Memorandum

Date: April 20, 2020
To: Barbara Beard, MIG Inc.
From: Gicela Del Rio, T.E.
Subject: Traffic Circulation Review for the Proposed Almaden Country Day School Facility Master Plan

Figure 5
Almaden Country Day School Master Plan – Phase 1

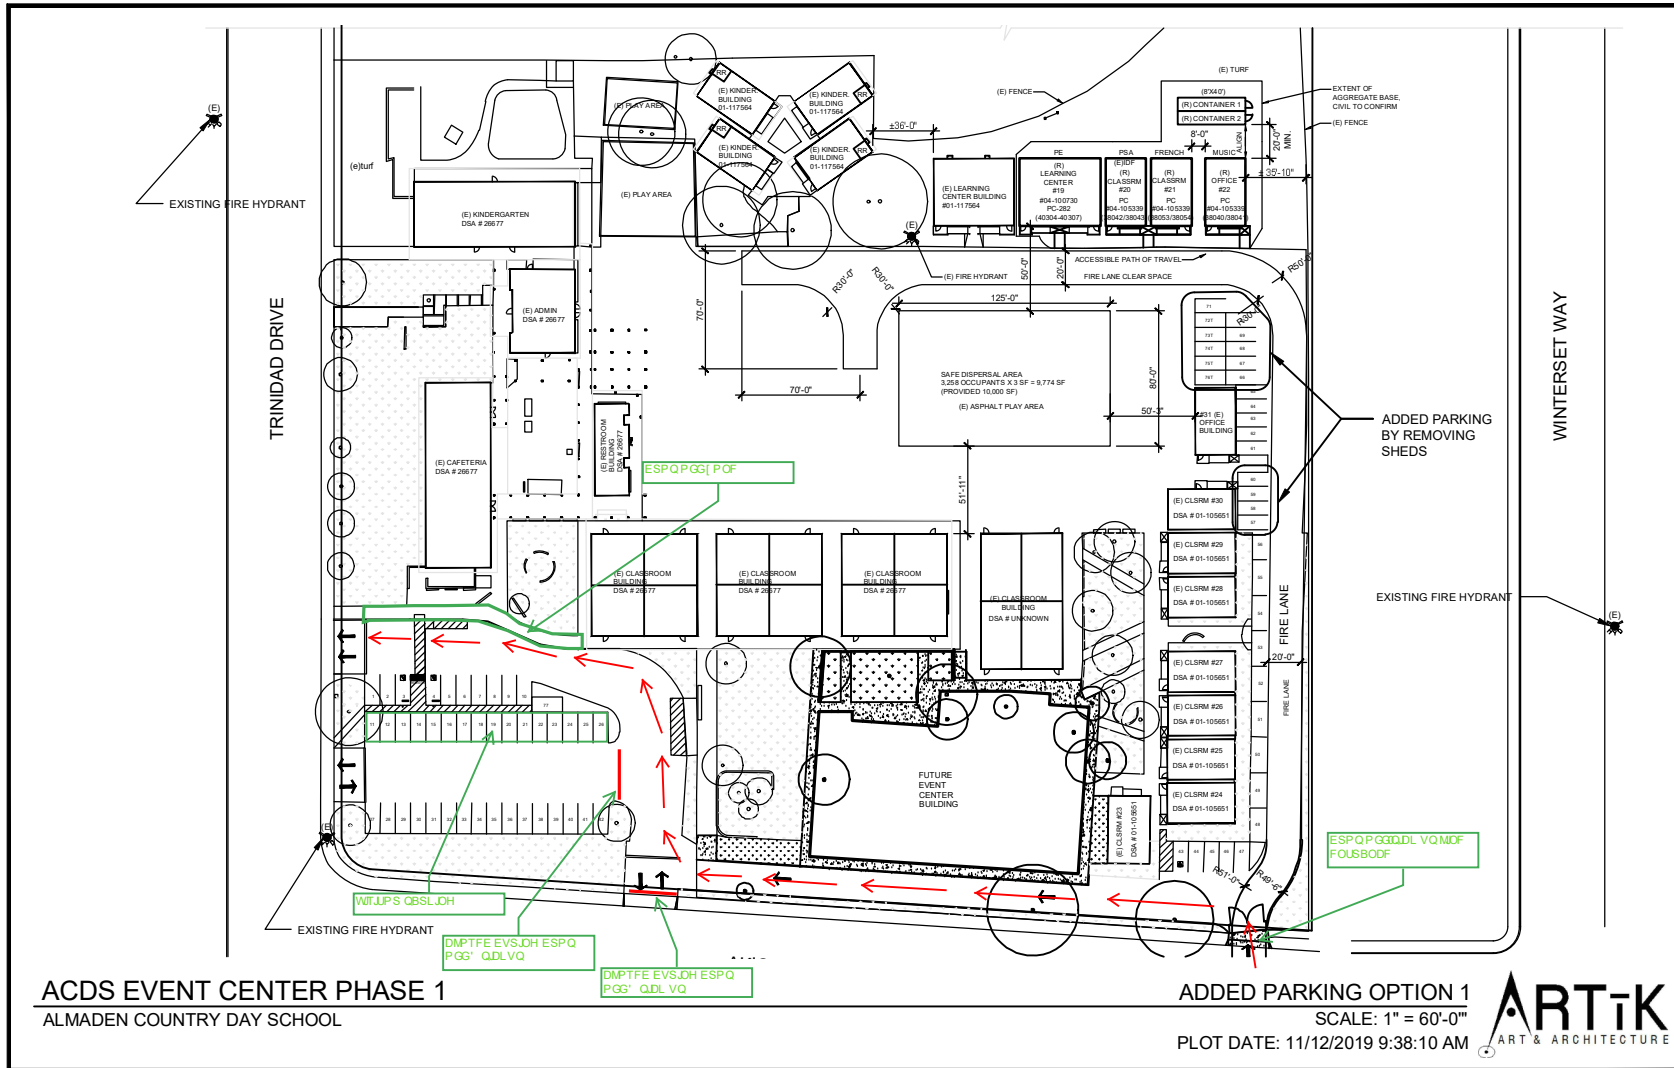
Phase 1 of the Master Plan would change the access to the drop-off area from the existing Akio Way inbound driveway (which would be closed off during the school's drop-off/pick-up times) to a new access driveway along Akio Way, at the southeast corner of the school site. However, drop-off/pick-up procedures would remain unchanged. Phase 1 would result in minimal disruption to the existing drop-off and pick-up activities on-site. As mentioned previously, 11 additional parking spaces (for a total of 77 parking spaces) would be provided after completion of Phase 1.

With the proposed parking and drop-off area layout at the completion of Phase 1, the on-site circulation would be relatively the same as under existing conditions. School traffic would enter the site via the new proposed driveway on Akio Way, travel westbound along the existing fire lane to the parking lot and drop-off area, then exit the site via the existing outbound driveway on Trinidad Drive. With the exception of ten parking spaces located across from the drop-off area, no parking would be provided along the drop-off lane, eliminating the conflict between parking vehicles and drop-off traffic and allowing for a continuous flow of traffic through the drop-off lane. At the parking spaces located across from the drop-off area, minimal activity is anticipated during the drop-off/pick-up periods since eight of the ten parking spaces would be assigned as staff parking and the other two would be accessible parking spaces. The access lane providing access between the new Akio Way driveway and the parking area is approximately 18 feet wide, adequate width for one-way access.

Under the proposed parking lot/drop-off area layout at the completion of Phase 1, the distance between the first position in the drop-off area and the new Akio Way driveway would be approximately 600 feet, or 24 vehicles. Based on the observed existing queue length, after the completion of Phase 1, the maximum vehicle queue from the drop-off area would be able to store within the school site.

The Phase 1 site plan shows a total of three accessible parking spaces on site, two located adjacent to the pedestrian pathway, across from the drop-off area, and a third located north of the new Akio Way driveway. The accessible parking spaces are located within what appears to be the shortest distance between the parking areas and the school campus. However, the proposed number of accessible parking spaces would be one accessible parking space less than the ADA requirements.

- Designate one additional parking space as an accessible parking space in order to satisfy ADA requirements.

Figure 7
Existing Access and On-Site Circulation Procedures to Remain Under Phase 1

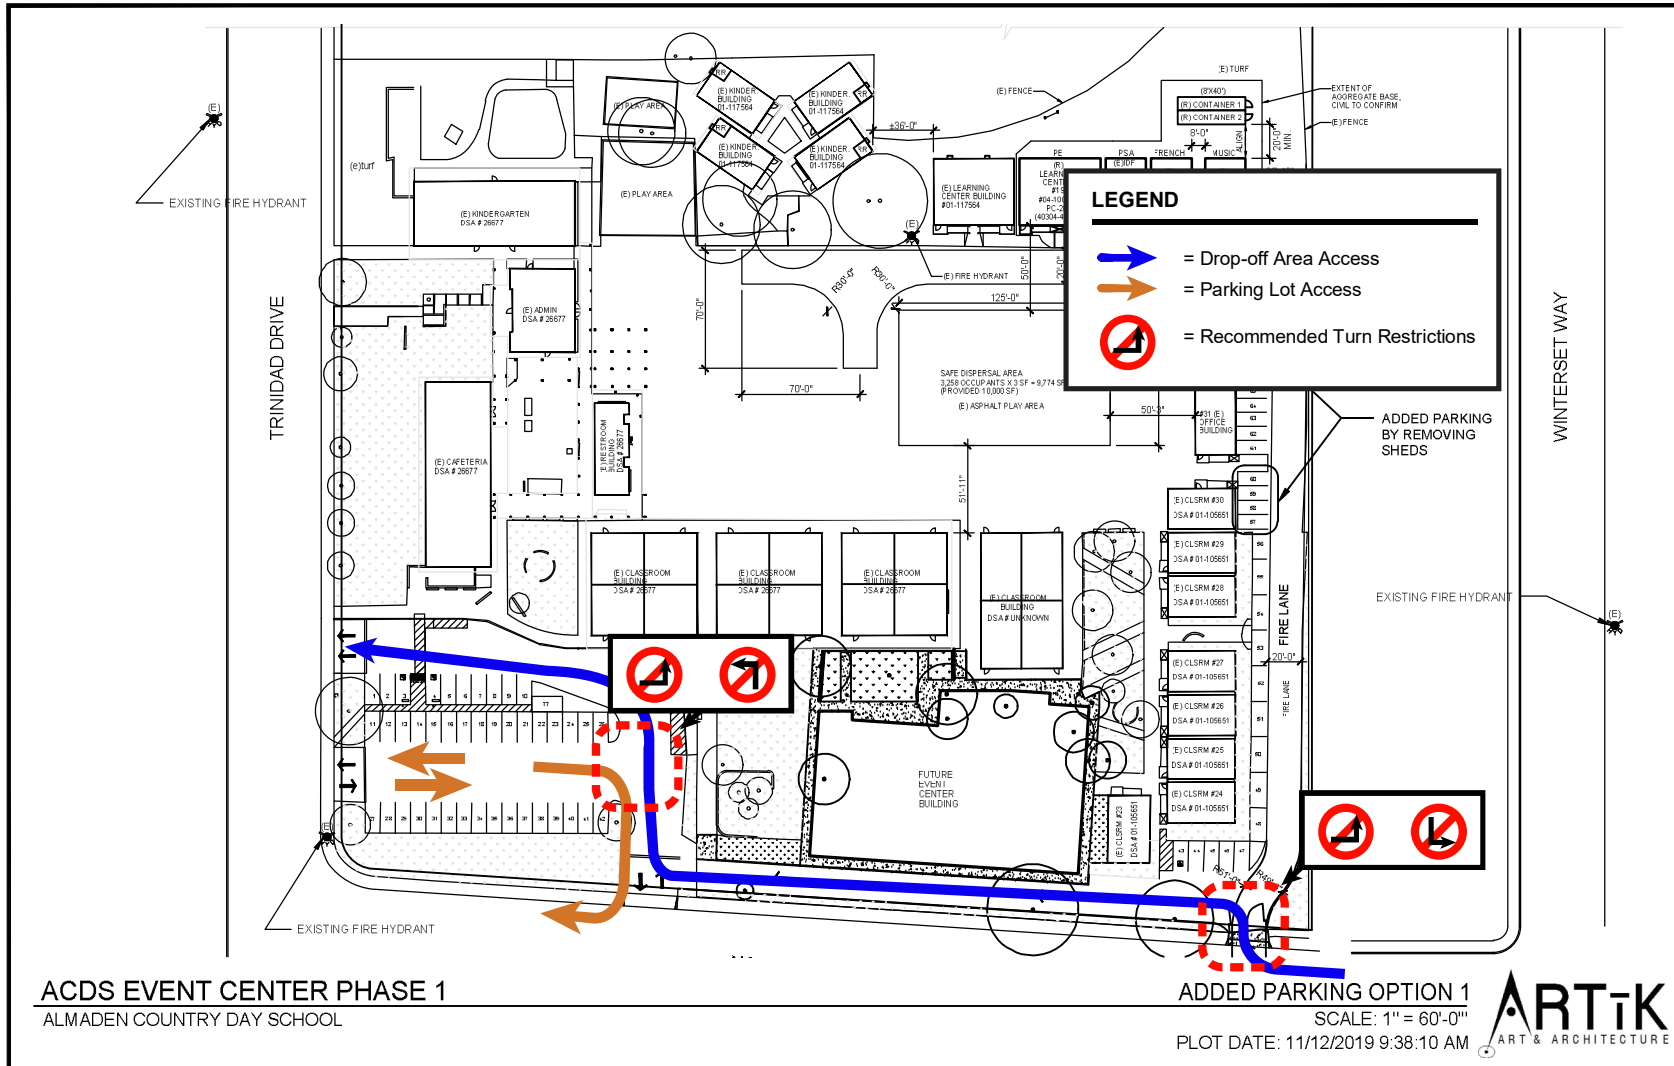
- Continue to implement existing site access procedures, with the required modifications as a result of the proposed new access driveway on Akio Way. This includes providing inbound access to the drop-off area via Akio Way and outbound access via Trinidad Drive. (Shown on the site plan)

- Continue the use of name cards displayed on the passenger side visor to help expedite pick-up procedures.
- Continue to prohibit left-turns into the Akio Way driveway. This avoids conflicting movements at the Akio Driveway and prevents vehicular queues from forming along the eastbound direction of Akio Way.

- Continue to provide all access to the parking area via the Trinidad Drive two-way driveway. (Shown on the site plan)
- Continue to prohibit vehicular access between the parking lot and the drop-off lane. (Shown on the site plan)

- All parents/students walking or parking on the street must continue to access the school campus via the marked crosswalks and pathways, avoiding crossing mid-block or at unmarked locations.

- Continue to emphasize that no U-turns should be completed mid-block or at the intersection of Winterset Way/Akio Way.

Figure 8
Recommended Access and On-Site Circulation Procedures – Master Plan Buildout

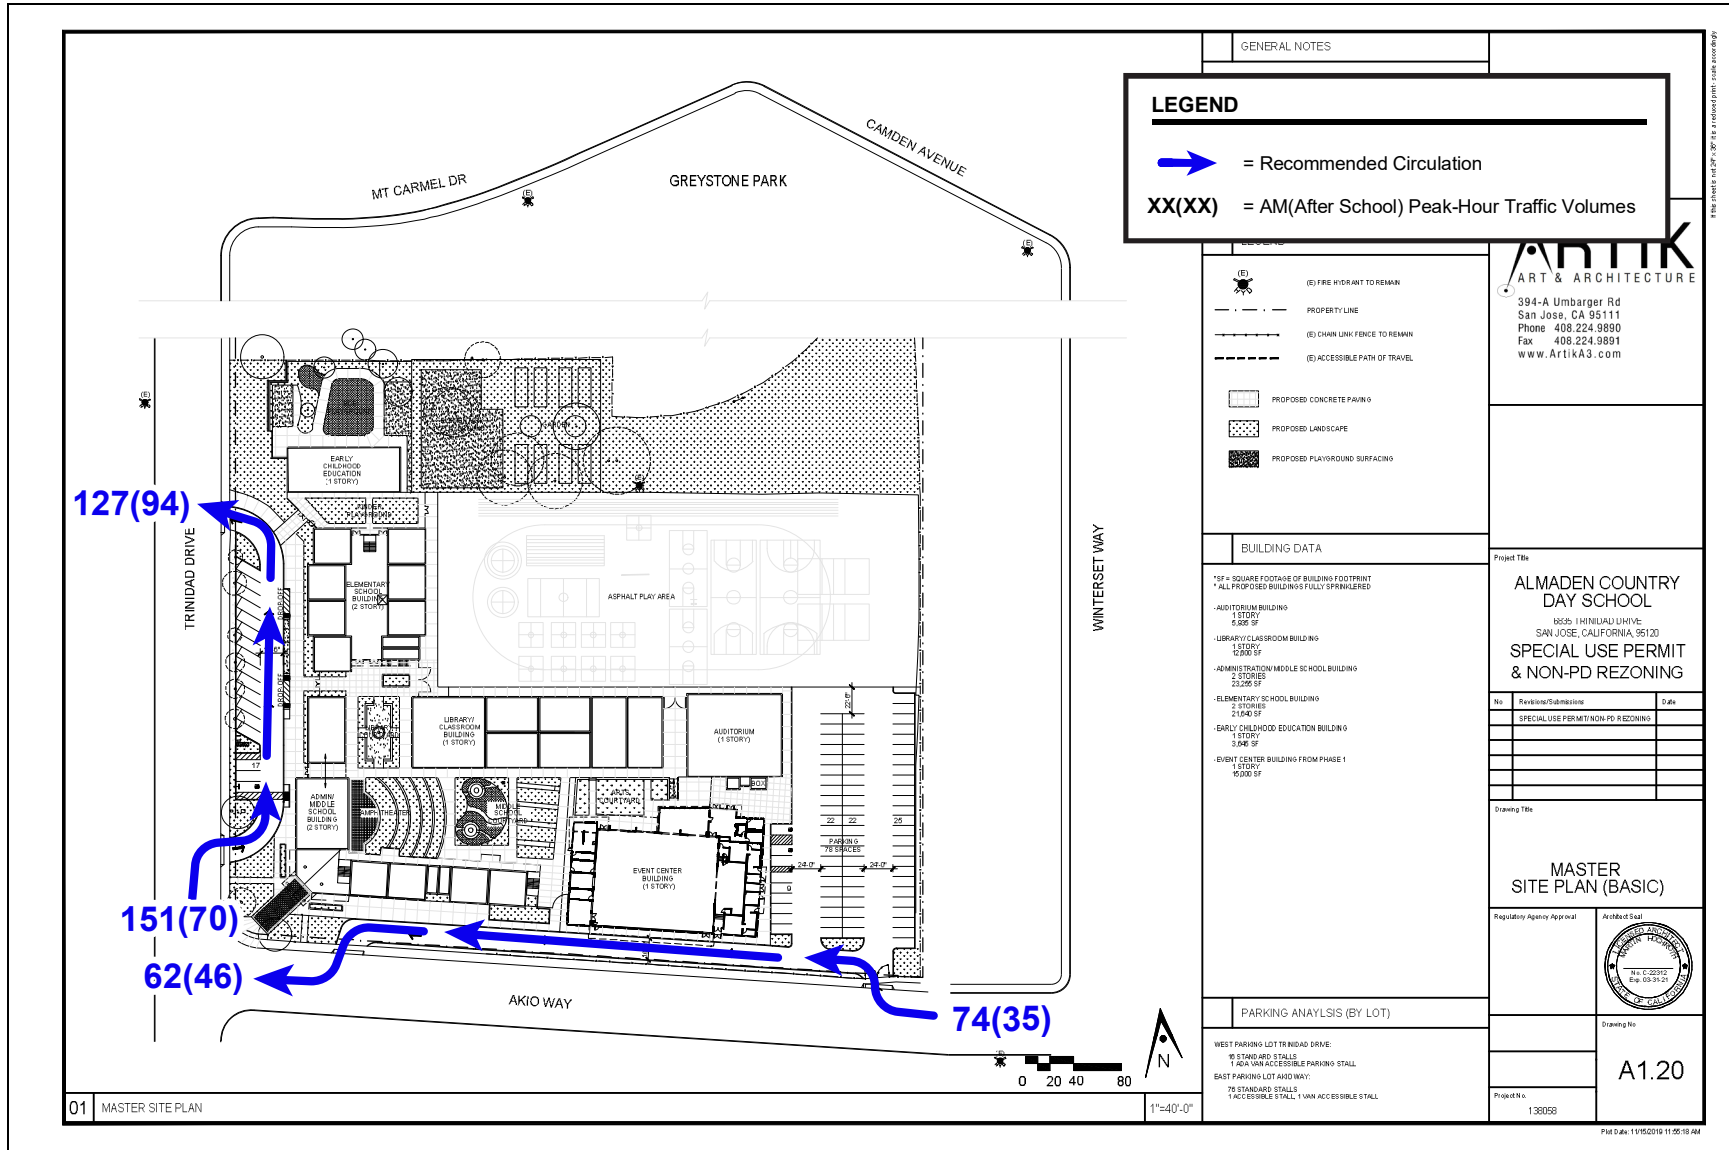
the maximum queue length at the Trinidad Drive drop-off area would extend approximate 30 vehicles, or 750 feet, extending from the first drop-off position past the Trinidad Drive/Akio Way intersection. This queue length could be shorter, depending on the number of parents that would continue to park and walk their students to class. If it is assumed that the same number of parents that currently park on the street would continue to do so under the Master Plan Buildout conditions, the number of vehicles entering the Trinidad Drive drop-off area during the peak 15-minute period would be 66 vehicles, translating into a 22-vehicle (550-foot) maximum queue length. A queue of this length would continue to extend beyond the Trinidad Drive/Akio Way intersection.

The maximum queue length at the Akio Way drop-off area would extend approximately 17 vehicles, or 425 feet, extending from the first drop-off position to the inbound driveway.

Although the implementation of two drop-off areas and parking lots would eliminate vehicles queues spilling onto Akio Way from the Akio Way driveway, the maximum queue length from the Trinidad Drive parking lot could extend back past the Trinidad Drive/Akio Way intersection, potentially affecting operations at the intersection and conflicting with the outbound traffic from the Akio Way drop-off area.

The Master Plan site plan shows a total of three accessible parking space provided on site, one within the Trinidad Drive parking lot and two within the Akio Way parking lot. The proposed number of accessible parking spaces would be one accessible parking space less that the ADA requirements.

- Continue to provide a minimum of five drop-off positions at each of the drop-off areas, in particular at the Trinidad Drive drop-off area, which is estimated to serve a larger number of students.

- Consider assigning some of the elementary grade students to the Akio Way drop-off area, since this drop-off area would provide a longer drop-off lane for queue storage.

- Consider providing a two-lane drop-off area, in particular at the Trinidad Drive parking lot. This would expedite drop-off procedures and reduce vehicle queue lengths. However, two drop-off lanes would require extensive monitoring of the drop-off area by staff/parents since children would have to cross one line of vehicles. Procedures for a two-lane drop-off area could include lining up five vehicles per lane, loading/unloading students into/out of the vehicles, and staff directing vehicles to exit the site once all 10 vehicles have completed their drop-off/pick-up.

- Designate one additional parking space as an accessible parking space in order to satisfy ADA requirements.
